# NOTICE OF DECISION

**HISTORIC DESIGN REVIEW CASE NO.:** HIS19-12

**SUMMARY:** A proposal to replace the front and side entry roofing and adjacent siding on the Joseph and Lillie Adolph House, c1923.

**HISTORIC DESIGN REVIEW CASE NO. HIS18-22  
DECISION**

Before

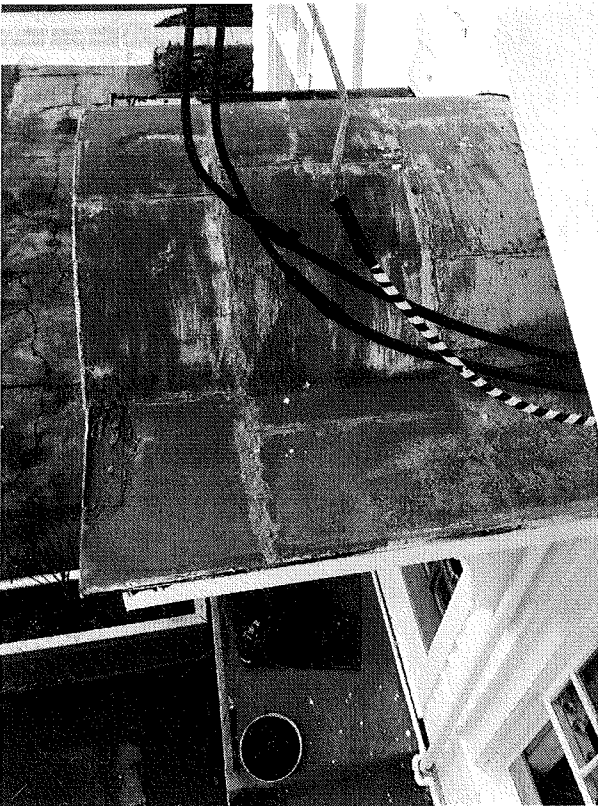
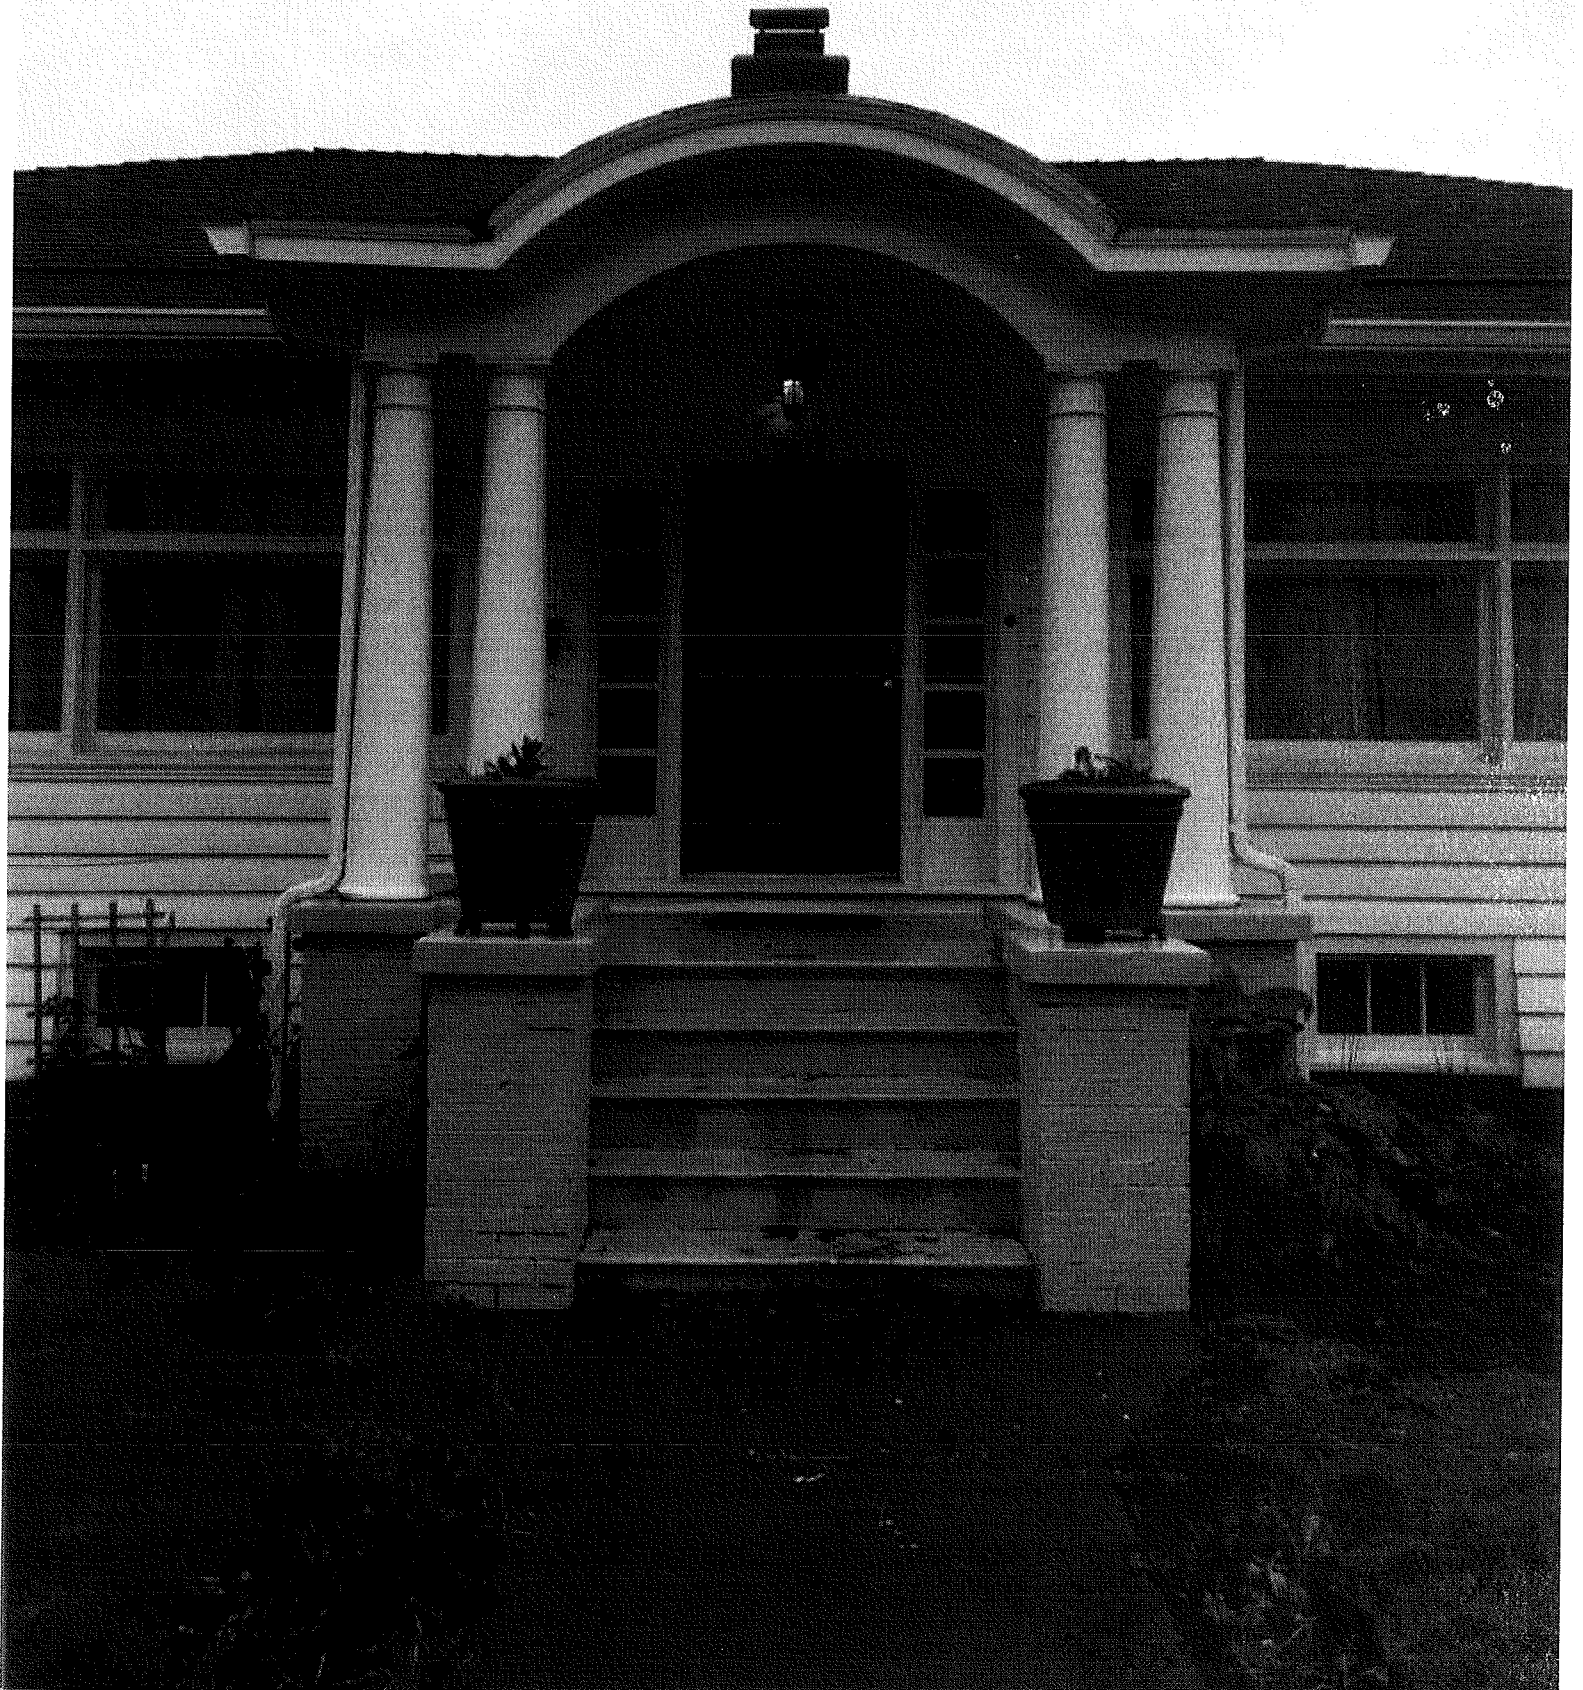
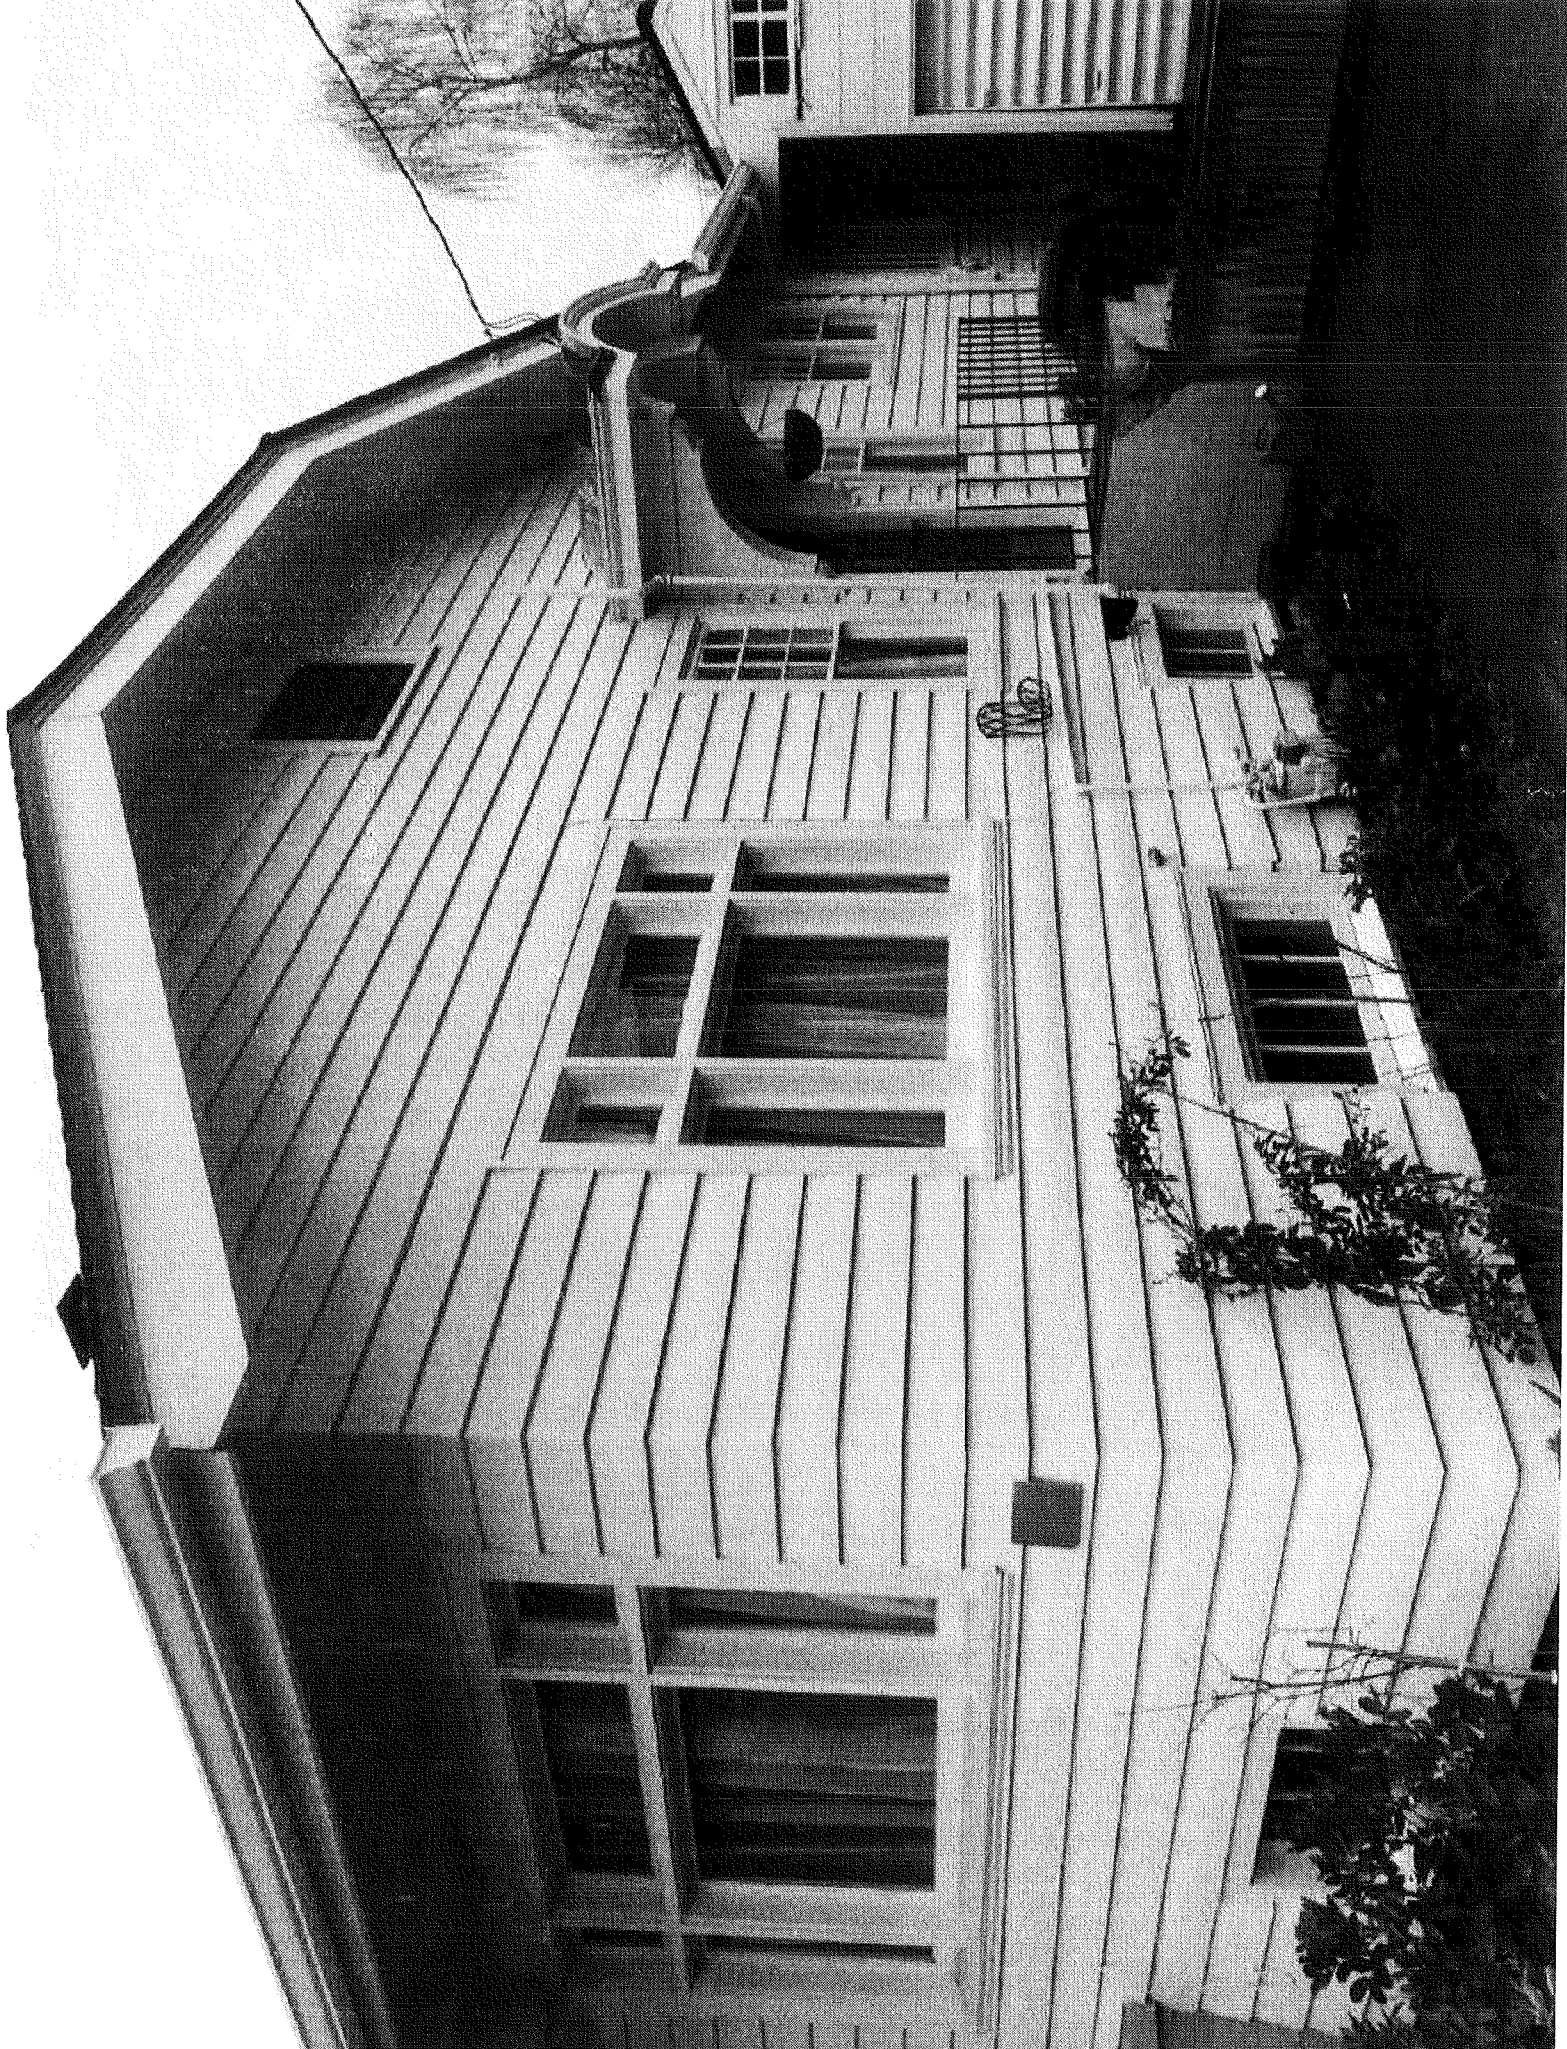
The existing roofing on the east and south arch canopy entrances of the resource are suffering from rust and decay caused by water damage. The dysfunctional roofing has caused rotting of adjacent wooden soffit, fascia board, and siding which has allowed water intrusion into the building (**Attachment C**). Due to poor condition caused by water leakage, the applicant is proposing to replace the existing galvanized steel roofing on the east and south entrance of the resource with sheet copper roofing (**Attachment C1**) and Mule-Hide Ethylene Propylene Diene Monomer (EPDM) rubber membrane underlayment to prevent future water leaks (**Attachment C2**). To prevent any future water damage to the arched roofs, the applicant is proposing to use copper head metal roofing screws with neoprene washers to seal any intrusions (nail holes) into the copper roofing.

**Finding:** The applicant is not proposing to cut back the roof rafters, soffits, or adding fascia boards where none existed. Due to rotting and decay, the applicant is proposing to replace the existing soffit, fascia board, and shingle molding adjacent to the arch canopy entrances where the water damage has occurred (**Attachment C**). Staff finds that SRC 230.025(e)(2)(C) has been met.

Attachment C1: Photo of Copper Sheeting Sample

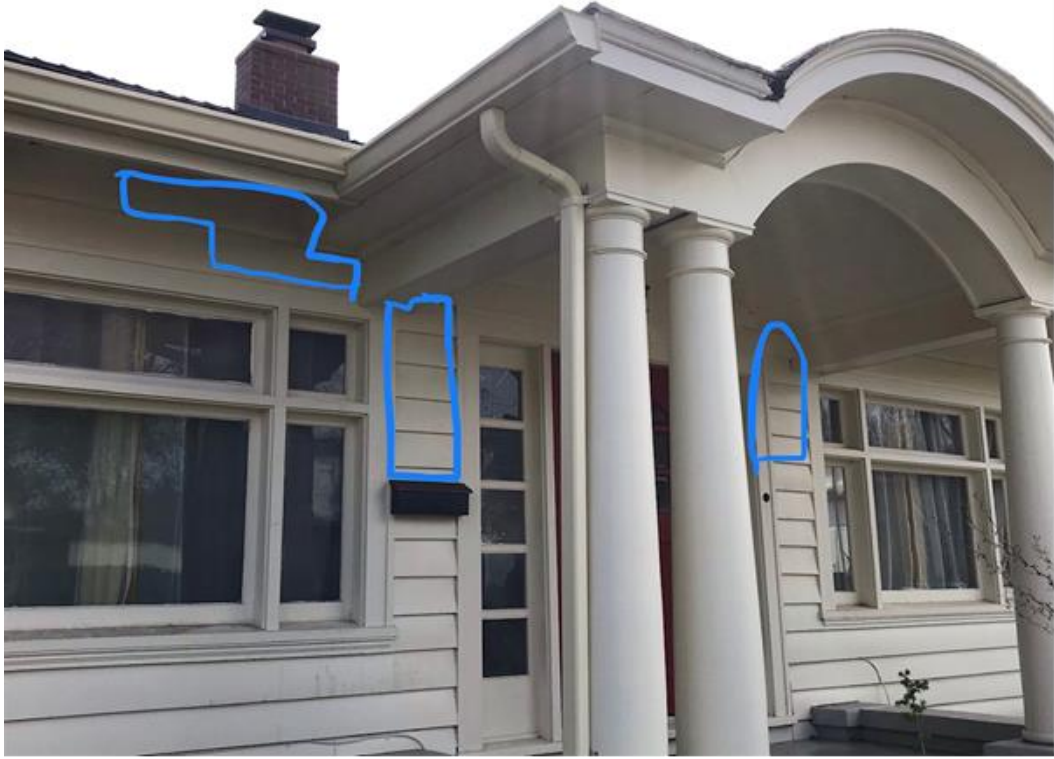
**Finding:** The applicant is proposing to install a new metal roof (copper) which is substantially the same material as the existing. The applicant is proposing to replace the existing galvanized steel roofing with copper sheet metal panels soldered with silver on all seams. To protect from future water damage, the applicant is also proposing to place a Mule-Hide 60 and 90 mil thick Ethylene Propylene Diene Monomer (EPDM) rubber membrane underlayment to prevent future water leaks (**Attachment C2**). The underlayment will not be visible thereby minimizing any potential visual adverse effect to the resource. To prevent any future water damage to the arched roofs, the applicant is proposing to use copper head metal roofing screws with neoprene washers to seal any intrusions (nail holes) into the copper roofing.

The proposed roof is metal, which is substantially the same material as the existing. While the copper material will appear differently from the existing roof material, the metal roofing replacement is compatible with the existing resource, and staff finds that SRC 230.025(e)(1)(B) has been met.
